DP-35 - WOMER'S CRESTVIEW VILLAGE  
Community Unit Plan for southwest  
corner Woodlawn & 21st St. Womer

DATA SHEET  
COMMUNITY UNIT PLAN

DP-35t- WOMER'S CRESTVIEW VILLAGE Community Unit Plan

DP-35 - Womer's Crestview Village Community Unit Plan and  
Z-1111 - Zone change from "AA" to "LC"

**LANDSCAPE SCREENING PLAN**  
**DP-35, WOMER'S CRESTVIEW VILLAGE C.U.P.**

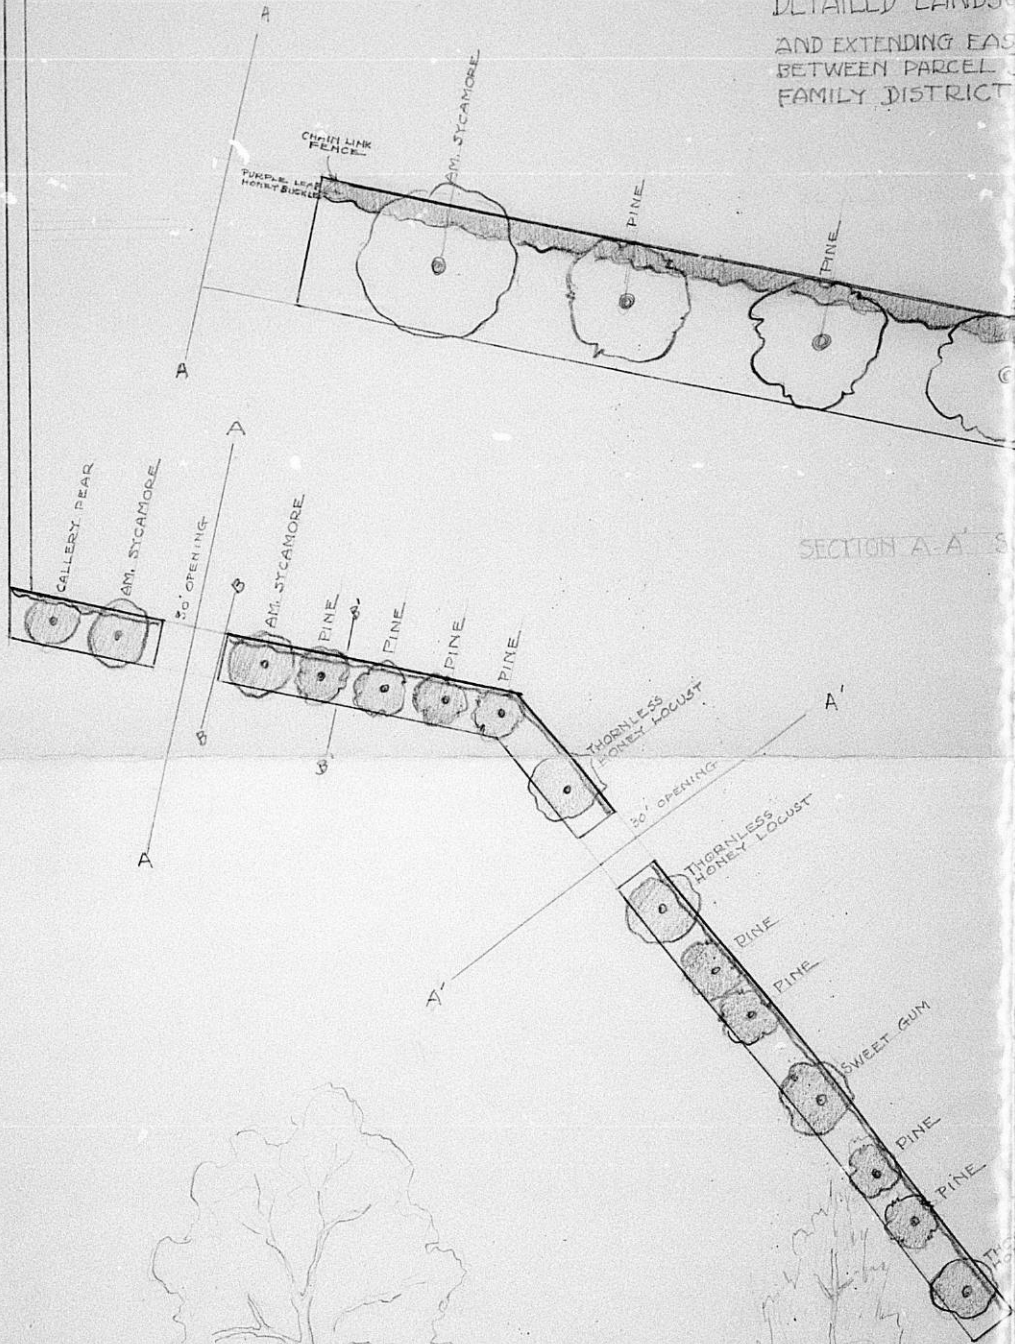
Enclosed please find Landscape Plan illustrating the make-up of the planting strip. We would appreciate hearing from you in the near future concerning the relocation of the strip and also would appreciate comments or suggestions which you may have concerning the Landscape Plan.

*Landscape Plan  
Approved on 12/2/50  
J.H.D.*

COMMUNITY UNIT PLAN

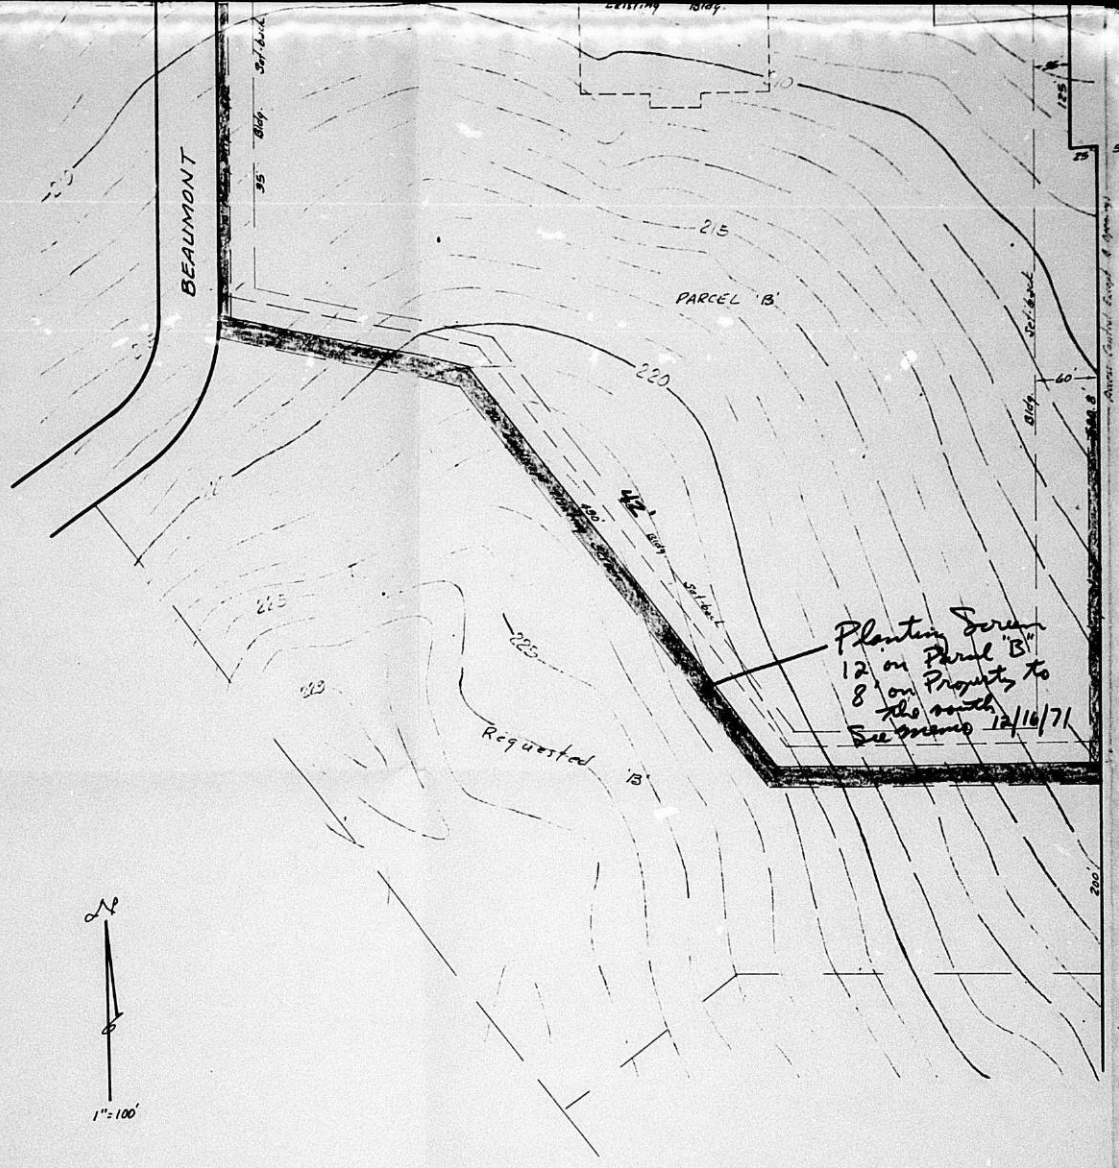
Planting Screen  
12' on Parcel 'B'  
8' on Property to  
the south  
See memo 12/16/71
